Page 2 - Herbert J. Nevyas, M.D.

Cumulative Ablation Pattern with CI Treatment

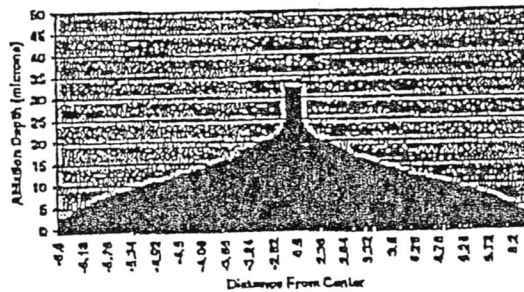
c. The pattern depicted below is from page 153 of your submission and shows theoretically the cumulative effect of a -3.0 diopter ablation using your multizone, multipass ablation algorithm.

As seen in the diagram, it appears that the central 2 mm of the ablation is flat (uncorrected), with steep slope (approximately infinite) for about 25% of the ablation depth (8 microns out of 32 microns), then continuing with more modest slope out to 6.6 mm. Please explain:

- i. During vision with narrowed pupils at 2 mm diameter, is the refraction of the cornea the same as prior to surgery (since that area did not receive a modification of the curvature)?
- ii. During vision with pupils greater than 2 mm diameter, will glare and halo be significantly increased?
- iii. Please relate this theoretical pattern to your profilometry measurements and explain any differences.
